DEVELOPMENT REVIEW BOARD – SPEED MEMO

DRB CASE NO/PROJECT NO: 1005127

**RE: TRACT 10 OF VOLCANO CLIFFS SUBD., UNIT 10
SKETCH PLAT SUBMITTAL**

**Sketch Plat for
Proposed Minor Subdivision of
Tract 10, Volcano Cliffs, Unit 10
Zone Atlas D-8 Sept., 2006**

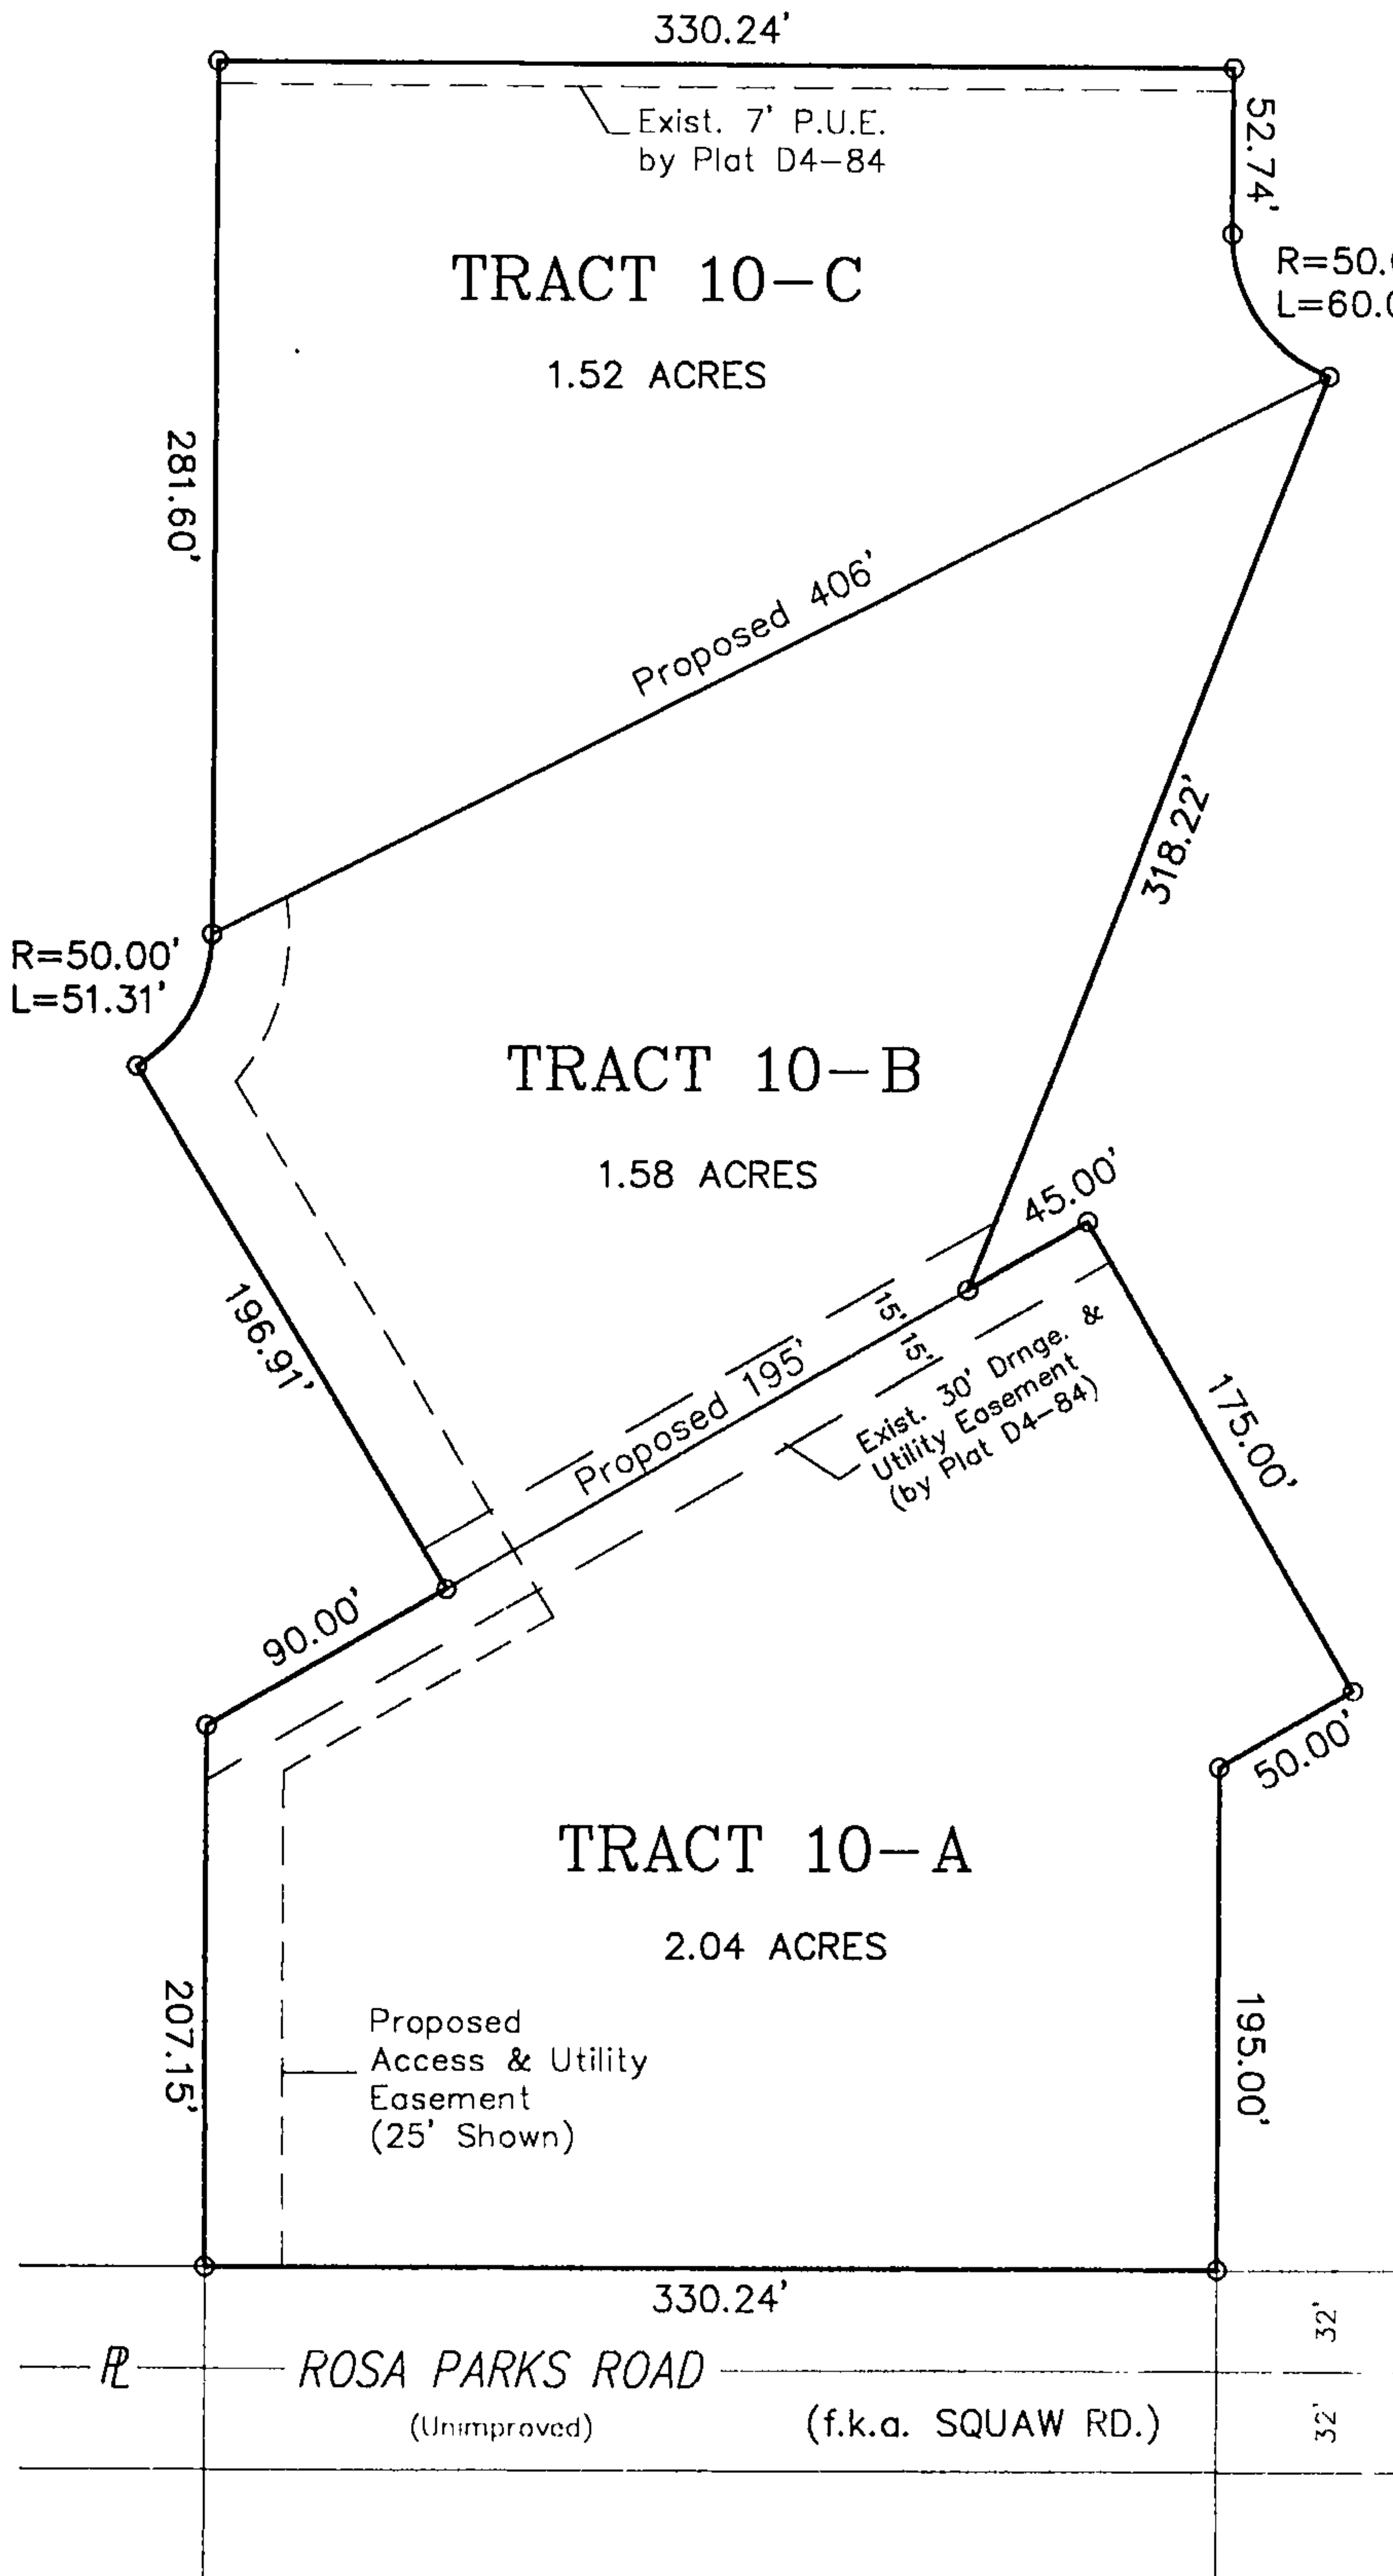
- 1) An infrastructure list is needed.
- 2) The width of Rosa Parks needs to be discussed with regards to the new Sector Plan and with street classifications. Rosa Parks may also require temporary paving to provide an all weather access.
- 3) Is this property part of the moratorium area?
- 4) Radii will be needed along the easement at corners.
